NextEra Energy Canada, ULC  
Goshen Wind Energy Centre

## **Natural Heritage Assessment and Environmental Impact Study Report Addendum**

60155032

January, 2013

**AECOM** Figure 1D

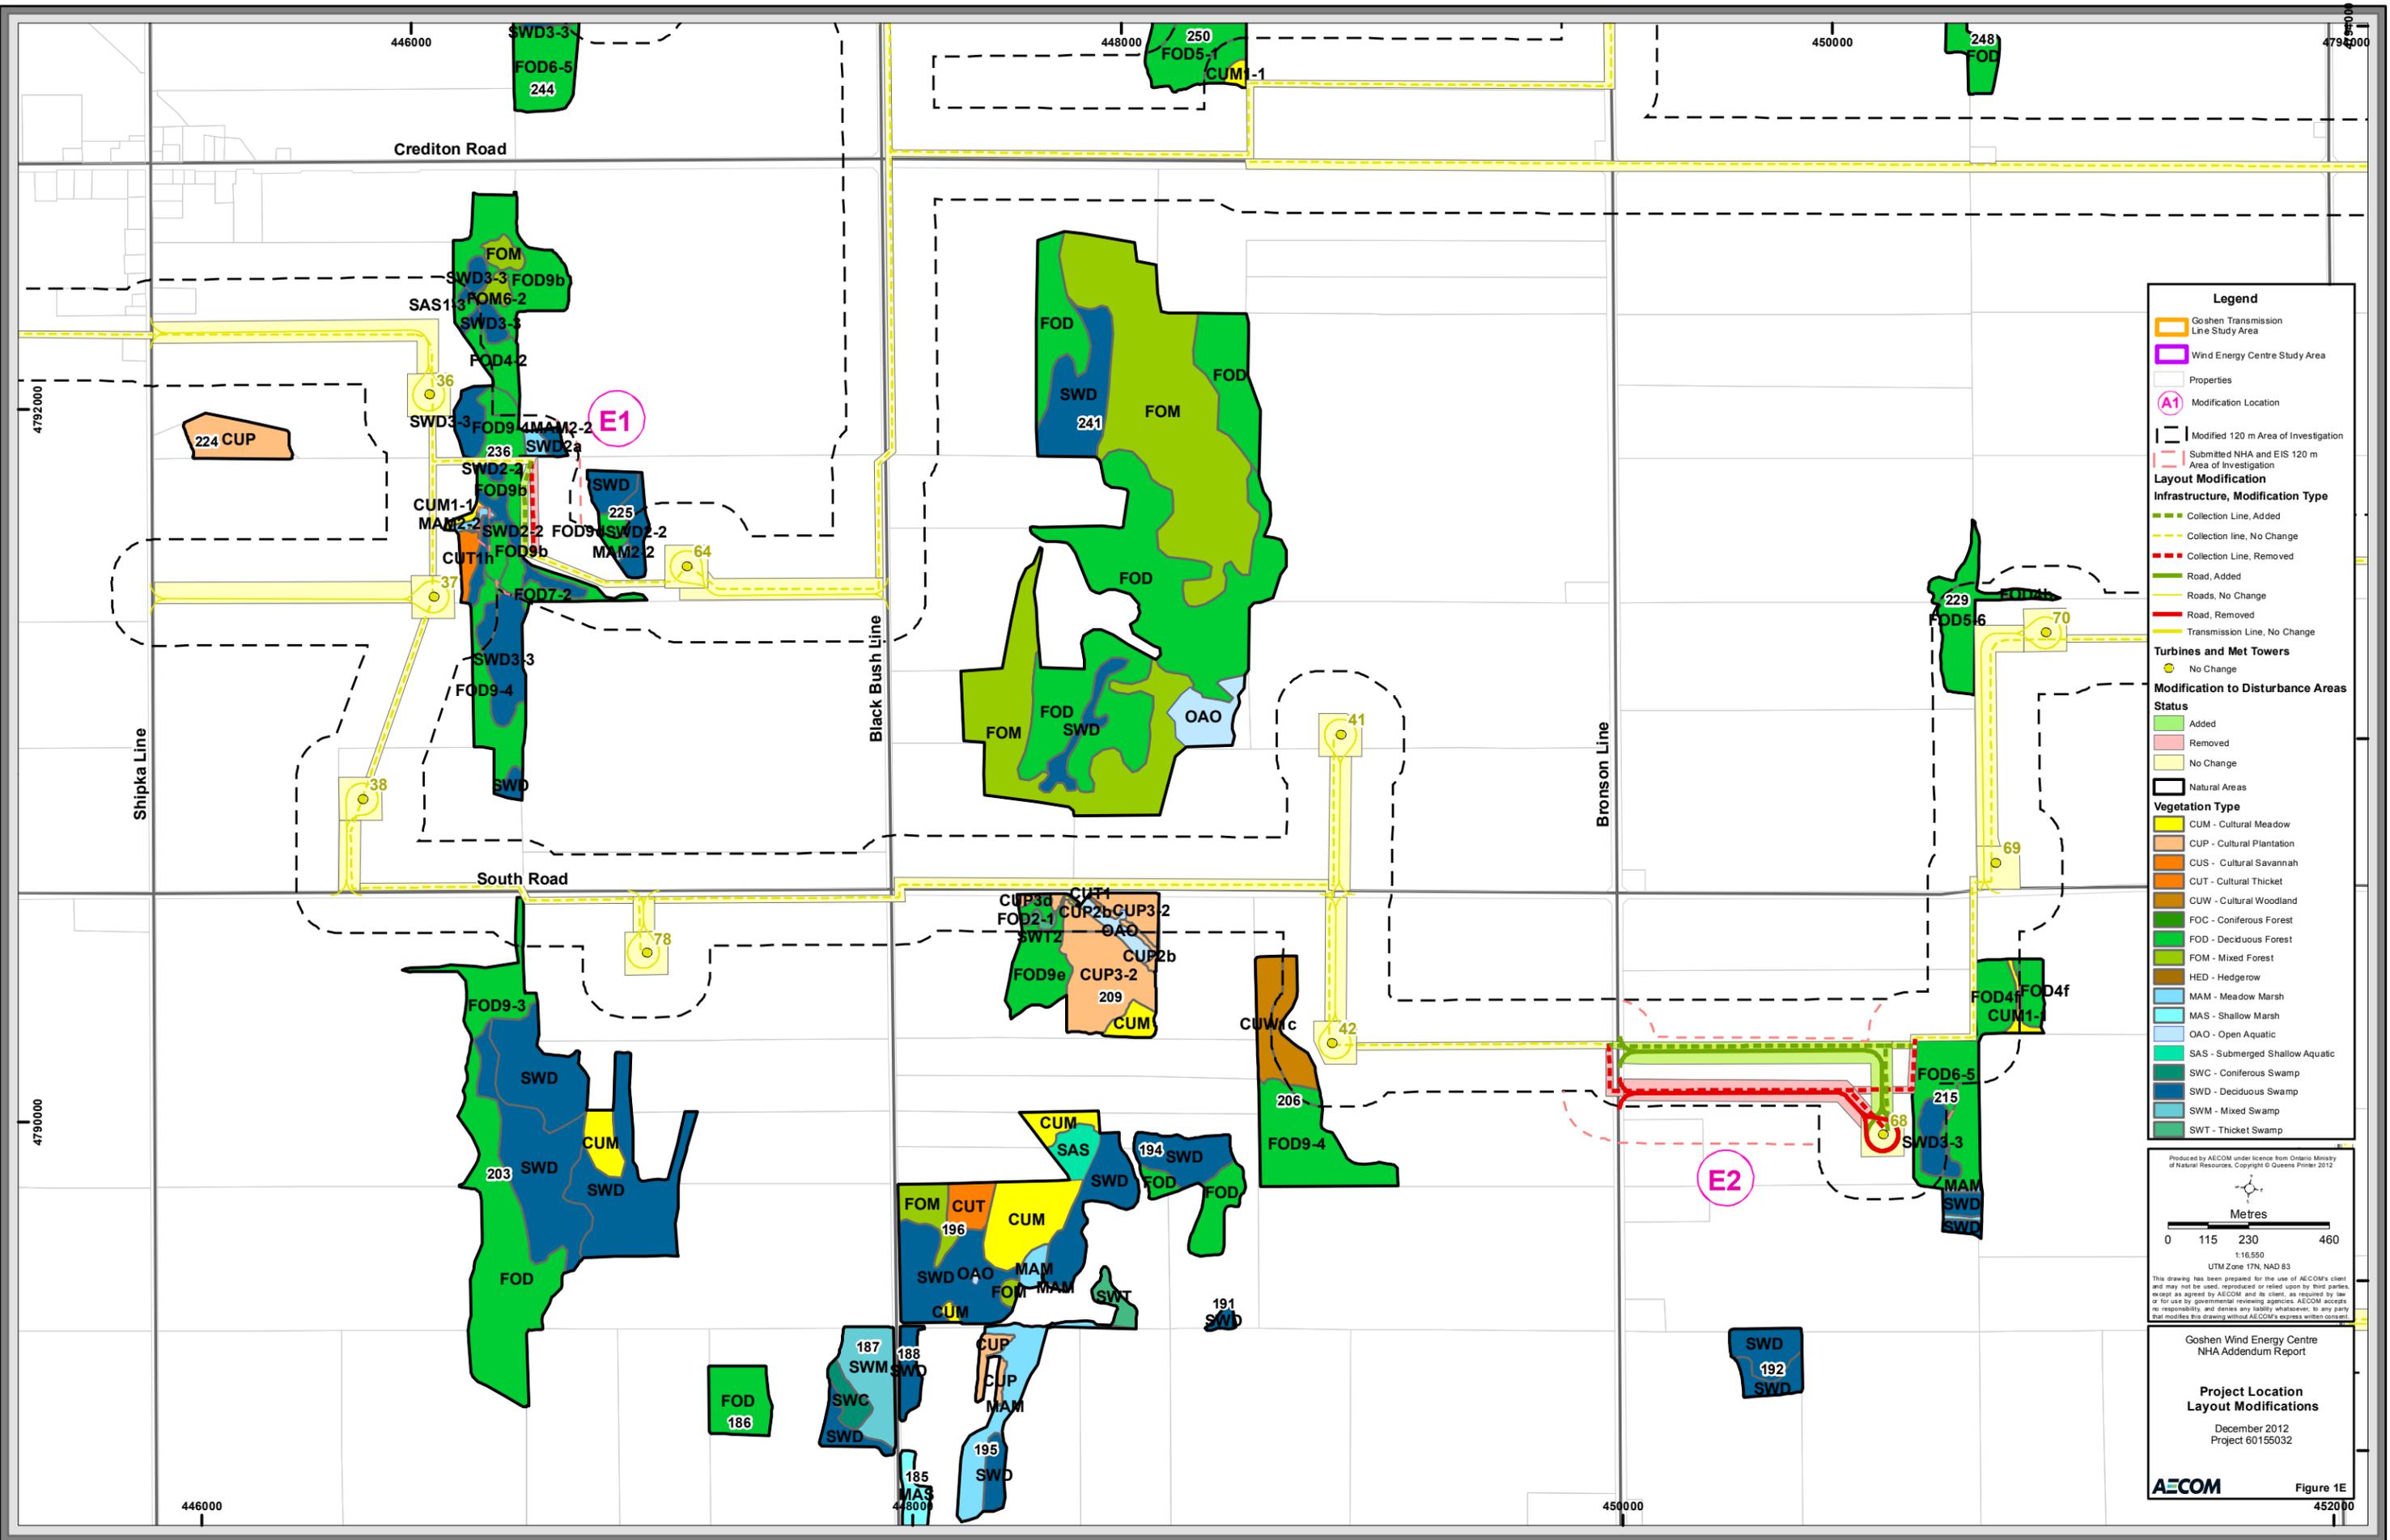
<b>C2:</b> Relocation of access road and collection line to Turbine 75 to southern property line.	None	Figure 1C
<b>D1:</b> Minor realignment of access road to meteorological tower.	None	Figure 1D
<b>E1:</b> Relocation of collection line between Turbines 36, 37 and 64, to run adjacent to boundary of natural area 236.	Collection line remains within 120 m of Natural Area 236. Features within 120 m of this modification include: <ul style="list-style-type: none"> <li>• Wetland Feature WET-010 (reduced from 3 m to &gt;0.1 m);</li> <li>• Woodland Features WOD-044 (increased from 30 m to 33 m) and WOD-054 (no change);</li> <li>• Candidate Significant Wildlife Habitat: <ul style="list-style-type: none"> <li>◦ Bat Maternity Colony Feature BMC-236 (no change);</li> </ul> </li> <li>• Generalized Candidate Significant Wildlife Habitat (Mature Forest Stand, Amphibian Breeding Habitat (Woodland), Amphibian Breeding Habitat (Wetland), Bird Species of Conservation Concern Habitat, Plant Species of Conservation Concern Habitat, Insect Species of Conservation Concern Habitat) (no change).</li> </ul>	Figure 1E

**AECOM** Figure 1F

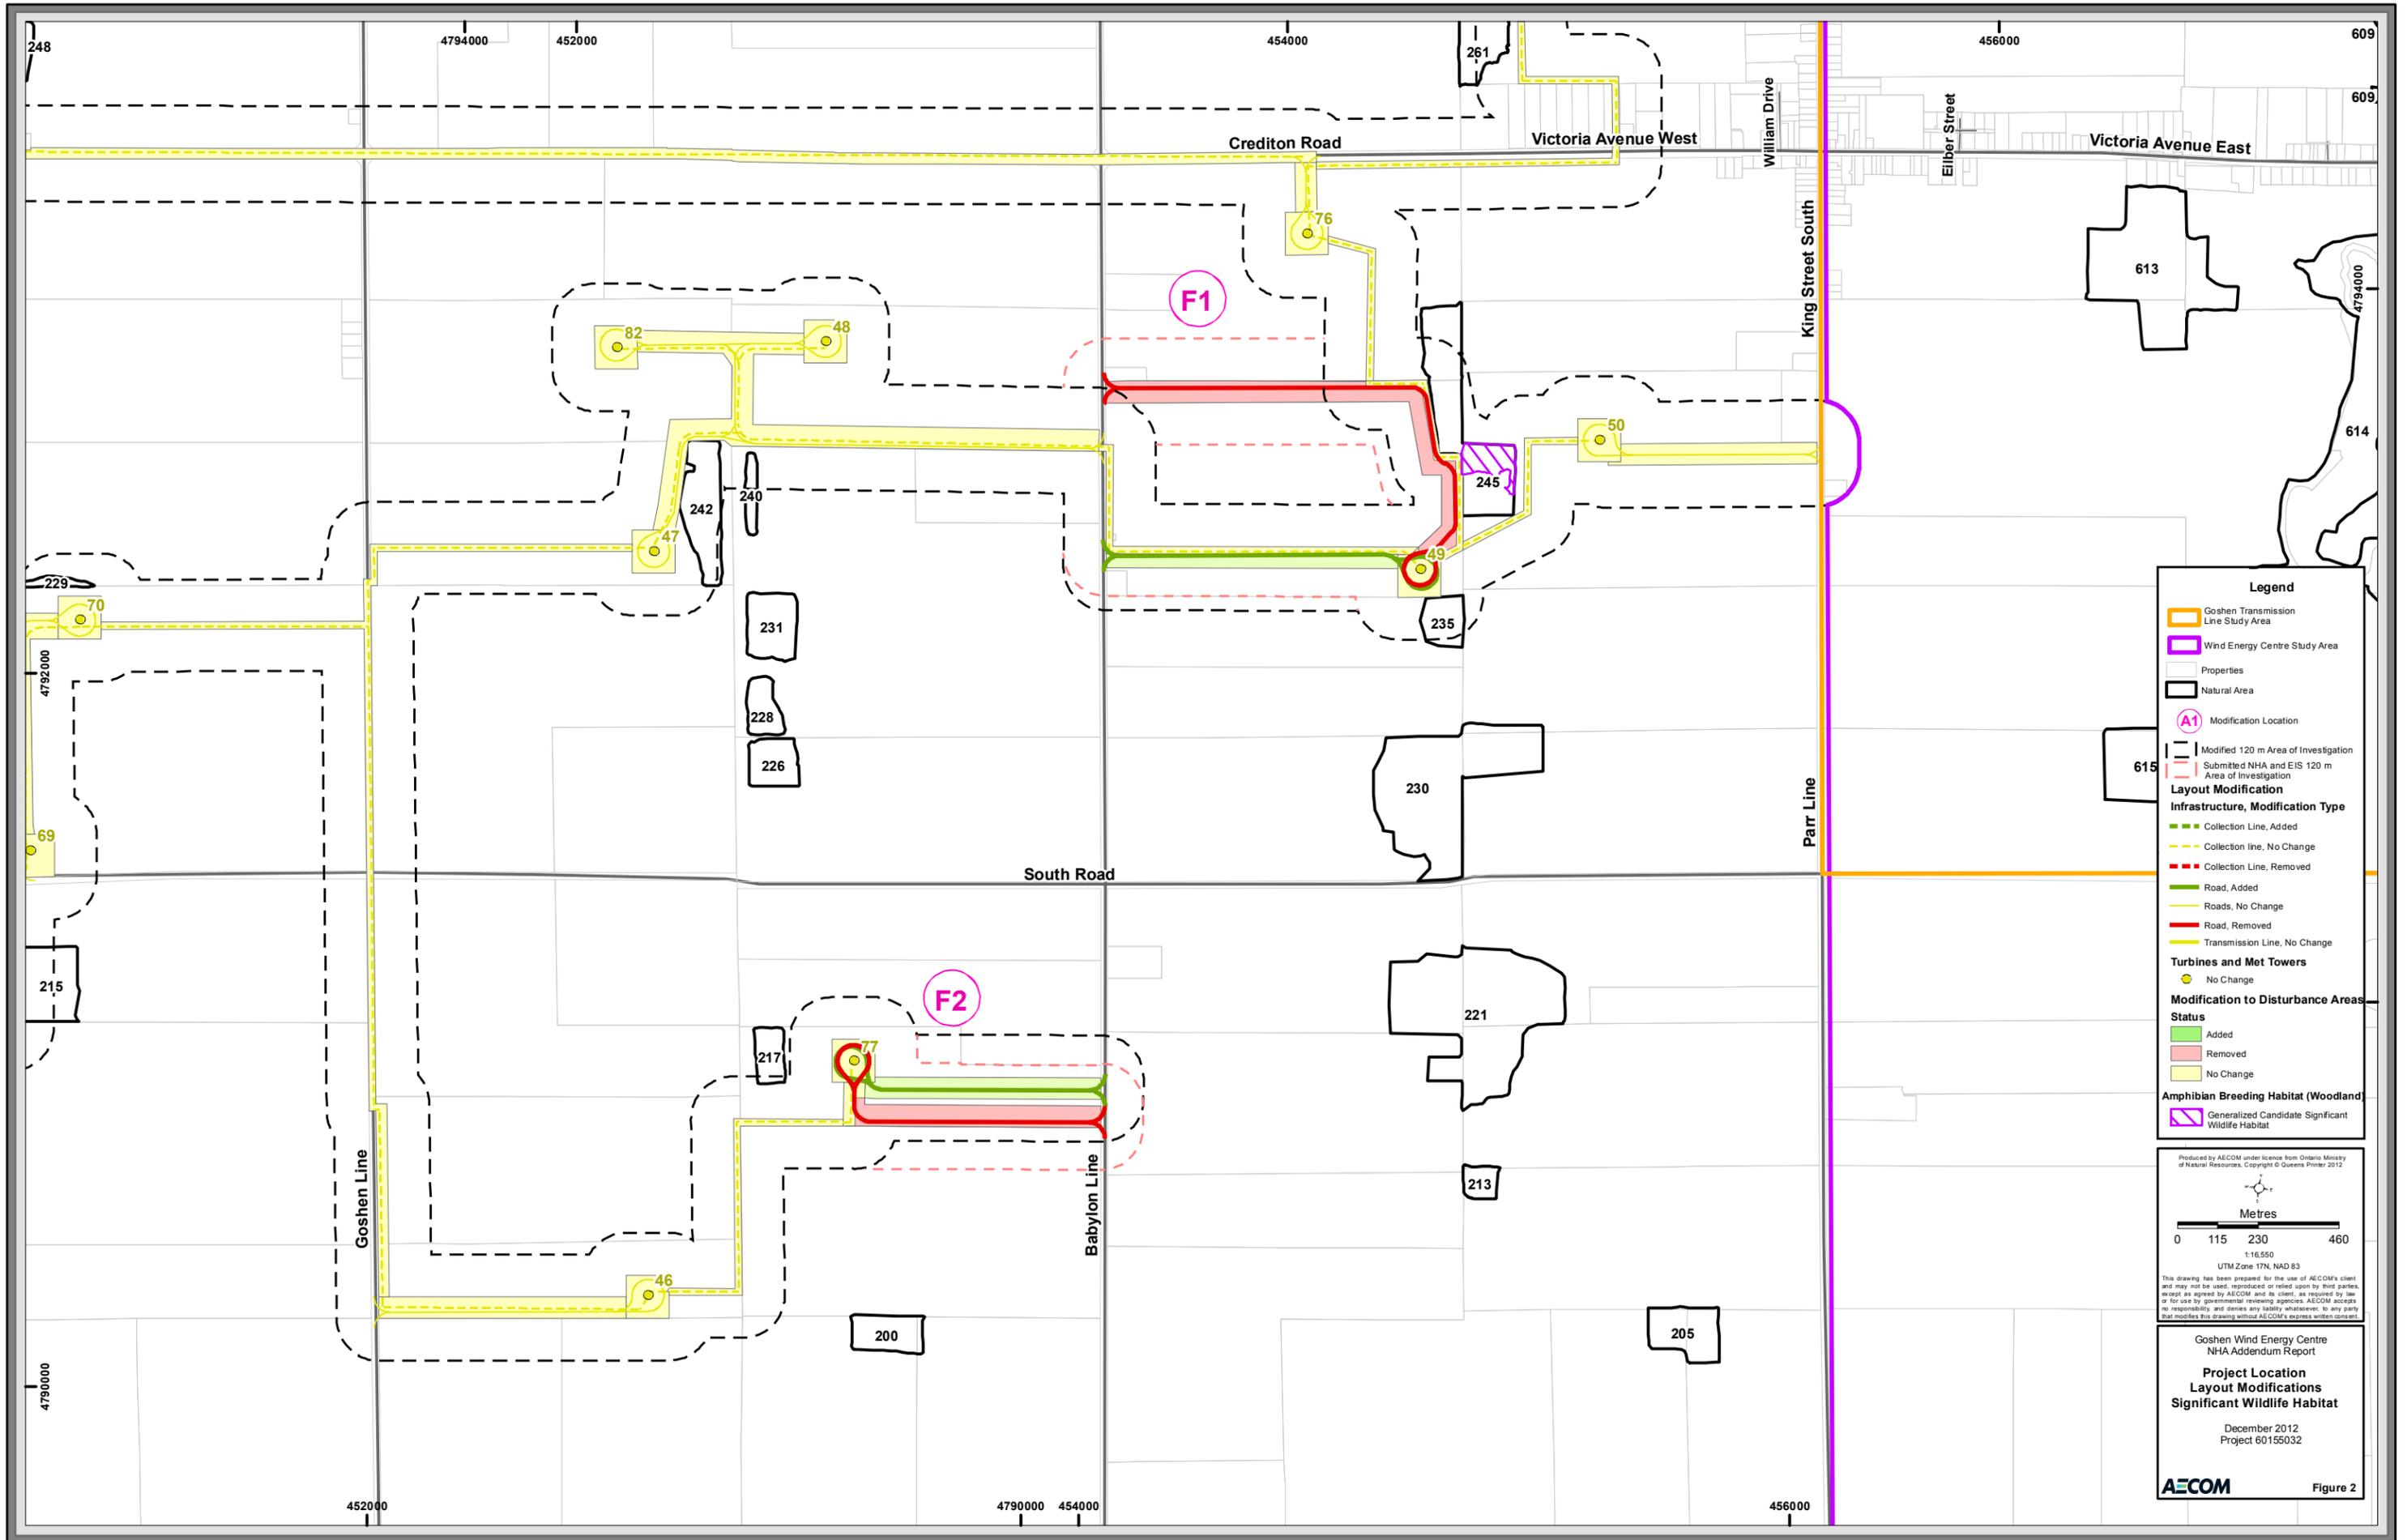
Modification ID	Feature(s) Potentially Affected by Proposed Modification (Change in Minimum Distance to Modified Project Component)	Map
<p><b>F1:</b> Relocation of access road to Turbine 49, to extend westward to Babylon Line.</p>	<p>Access road remains within 120 m of natural area 235. Features within 120 m of this modification include:</p> <ul style="list-style-type: none"> <li>• Wetland Feature WET-011 (no change);</li> <li>• Woodland Feature WOD-053 (no change);</li> <li>• Candidate Significant Wildlife Habitat:                             <ul style="list-style-type: none"> <li>○ Bat Maternity Colony Feature BMC-235 (no change);</li> <li>○ Reptile Hibernacula Feature RH-02 (no change);</li> <li>○ Amphibian Woodland Breeding Habitat Feature AWO-06 (no change);</li> </ul> </li> <li>• Generalized Candidate Significant Wildlife Habitat (Habitat for Plant Species of Conservation Concern, Habitat for Bird Species of Conservation Concern) (no change).</li> </ul> <p>Access road is no longer within 120 m Natural Area 245. Features within 120 m of this modification include:</p> <ul style="list-style-type: none"> <li>• Wetland Feature WET-011 (increased from &gt;0.1 m to &gt;120 m);</li> <li>• Woodland Feature WOD-064 (increased from &gt;0.1 m to &gt;120 m);</li> <li>• Candidate Significant Wildlife Habitat:                             <ul style="list-style-type: none"> <li>○ Amphibian Breeding Habitat (Woodland) Feature AWO-02 (increased from &gt;0.1 m to &gt;120 m);</li> </ul> </li> <li>• Generalized Candidate Significant Wildlife Habitat (Mature Forest Stand, Plant Species of Conservation Concern Habitat, Bird Species of Conservation Concern Habitat, Insect Species of Conservation Concern Habitat, Bat Maternity Colony) (increased from &gt;0.1 m to &gt;120 m).</li> </ul>	<p>Figure 1F</p>

<p><b>F2:</b> Relocation of access road to Turbine to northern property line.</p>	<p>None</p>	<p>Figure 1F</p>

An amphibian breeding habitat (woodland) feature in natural area 245 was identified as candidate Significant Wildlife Habitat (AWO-02) in the submitted NHA and EIS. However, due to modification F1, this feature is now more than 120 m away from the nearest access road; therefore, the designation of this feature is changed to Generalized Candidate Significant Wildlife Habitat (Figure 2). This feature was carried forward to the Evaluation of Significance of this NHA Addendum. No other changes to the designation of candidate Significant Wildlife Habitat and Generalized Candidate Significant Wildlife Habitat are required.

The designation of amphibian breeding habitat (woodland) feature AWO-02 changed from candidate Significant Wildlife Habitat to Generalized Candidate Significant Wildlife Habitat as a result of modification F1 (Figure 2). Consequently, pre-construction Evaluation of Significance surveys are no longer required for this feature. No other changes are required to the methods as described in the submitted NHA and EIS.

- Amphibian Woodland Habitat Feature AWO-02: The access road to Turbine 49 is no longer within 120 m of this feature (modification F1); therefore, the mitigation measures associated with Amphibian Woodland Breeding Habitat Feature AWO-02 no longer apply to this feature, as its designation was changed to Generalized Candidate Significant Wildlife Habitat. Instead, mitigation measures to address potential effects on Generalized Candidate Significant Wildlife Habitat, as described in Section 5.8.3 of the submitted NHA and EIS (refer to Table 5.6), will be applied to this feature.
